ATTACHMENT B - TECHNICAL DESCRIPTION

Myriota is amending its petition for declaratory ruling to access the U.S. market using its non-voice, non-geostationary (“NVNG”) mobile-satellite service (“MSS”) system (the “Myriota System”) of small satellites to provide low-power Internet of Things (“IoT”) services in the 137-138 MHz (space-to-Earth) and 148-150.05 MHz (Earth-to-space) bands (the “NVNG VHF Petition”).¹ This Technical Description provides the Federal Communications Commission (“Commission”) with information regarding changes to the Myriota System as required by 47 C.F.R. §§ 25.116 and other relevant sections of Part 25 of the Commission’s rules.

A.1 INTRODUCTION

FIGURE 2. Myriota 26 vs Myriota 36 Coverage – Alaska

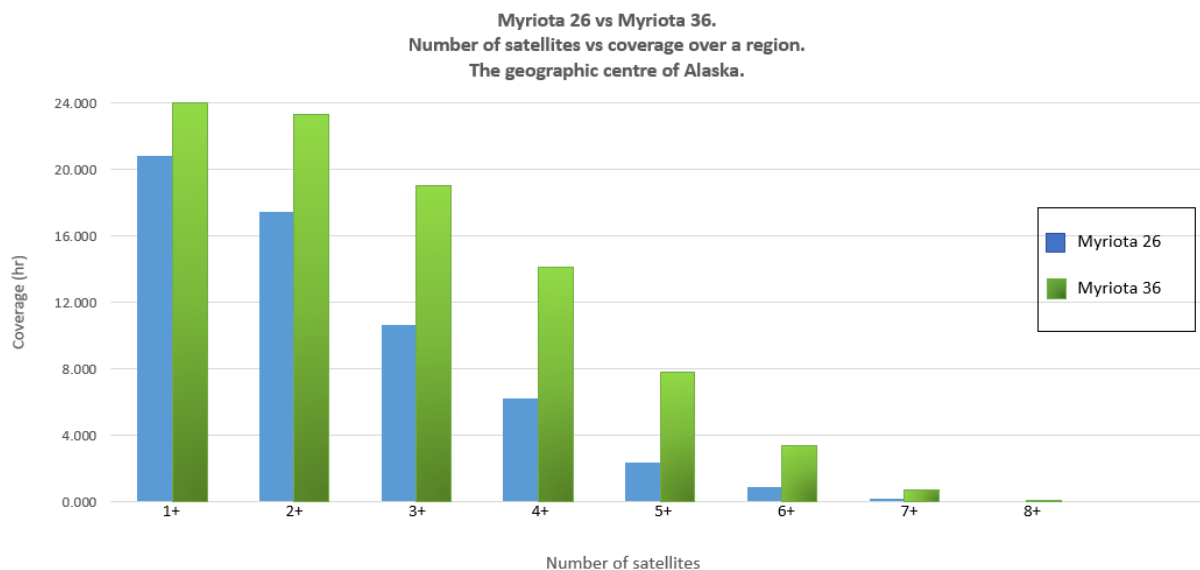
The average daily coverage and number of satellites covering each region, from highest to lowest latitude, are depicted in the following figures. Note that the coverage data is cumulative (*e.g.*, 2+ means two or more satellites covering the region).

The foregoing comparisons suggest that all three regions experience an increase in average daily coverage (*i.e.*, hours of 1+ satellite coverage) with the 36-satellite versus the 26-satellite system. In addition, high-latitude Alaska experiences increases in multiple-coverage for every number of satellites. However, the contiguous United States (“CONUS”) and Hawaii regions experience similar 2+ coverage and decreased multiple-satellite coverage from three or more satellites. Thus, the increase in 1+ coverage is offset by the decrease in multiple-satellite coverage.

FIGURE 5. Myriota 26 vs Myriota 36 Daily Satellite-Hours

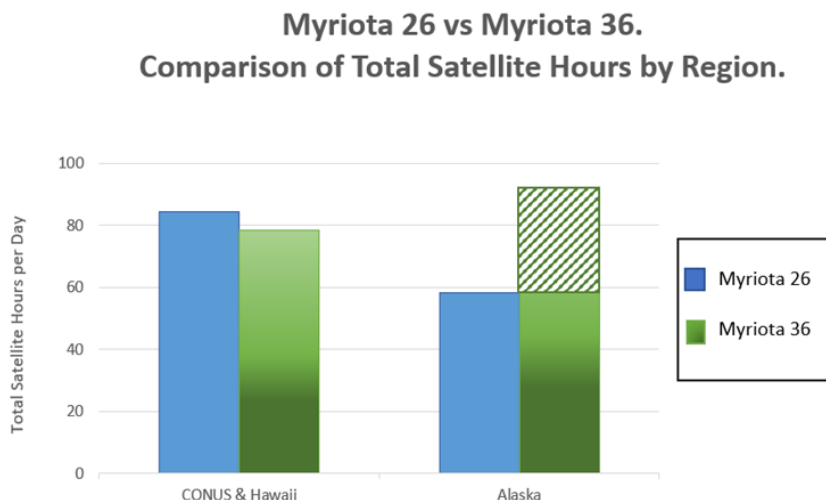
As indicated below, the total number of daily satellite-hours in CONUS and Hawaii decrease from approximately 84 to 78 while daily satellite-hours in Alaska increase from approximately 59 to 92.

The decrease in satellite-hours in CONUS and Hawaii – and thus decrease in the spectrum access impact of the Myriota System in these areas – results from the improved orbital architecture even though the number of satellites is being increased from 26 to 36. To offset the satellite-hour increase in Alaska, Myriota will control Myriota System operations to ensure that the spectrum impact of the system is no greater than that of the original 26-satellite system design.
